®ADEMCO 165 EILEEN WAY SYOSSET, NEW YORK 11791

PCB (REF)	N6739V6 REV.A
TITLE	SCHEMATIC
DRAWING NUMBER	SA5827BDR-1
COMPUTER FILE NAME	SA5827BDR-1.SCH
DATE: 3/31/03	SHEET 1 OF 1

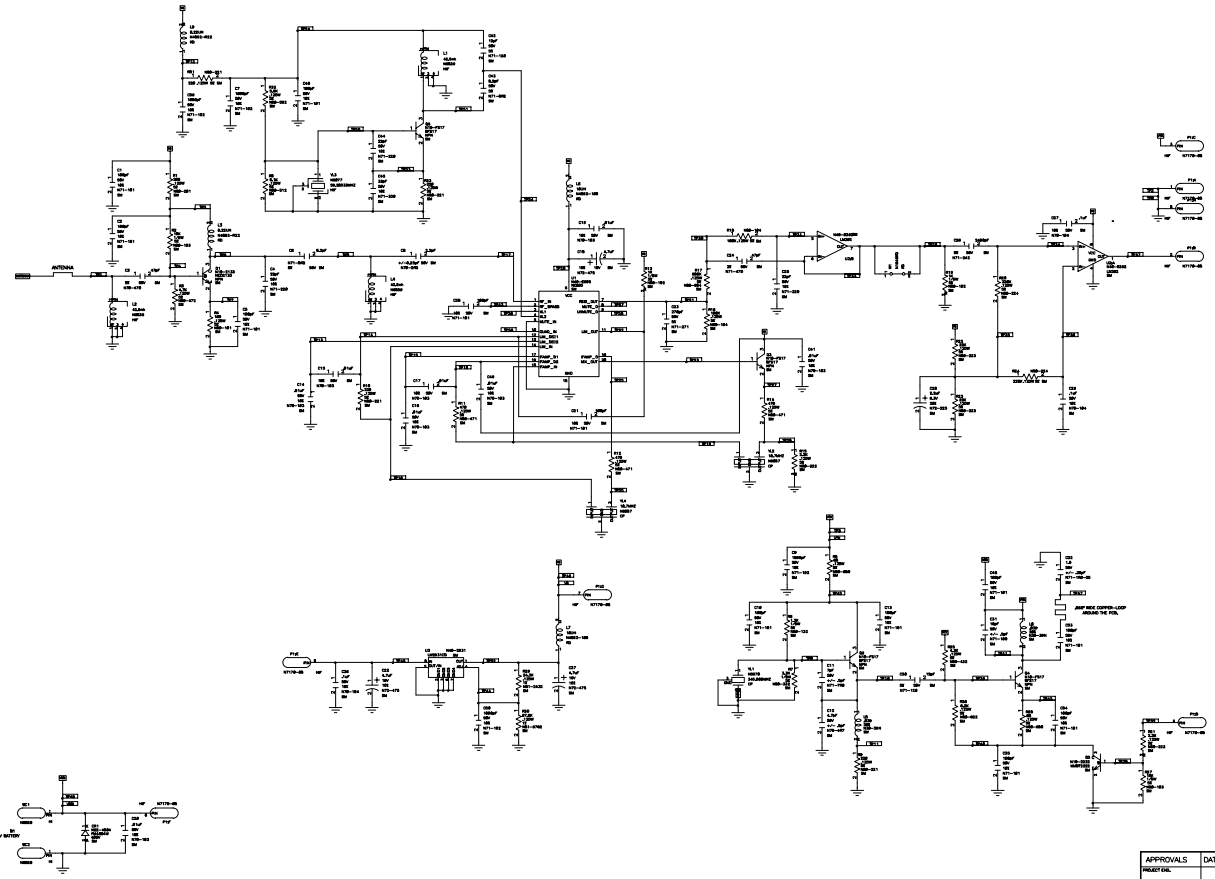
ASSY REV	DESCRIPTION	DATE	APPROVED
A	ECN27228 CHN. PCB TO V6, C42 WAS 6PF AND C43 WAS 15PF.	07-14-03	RB.
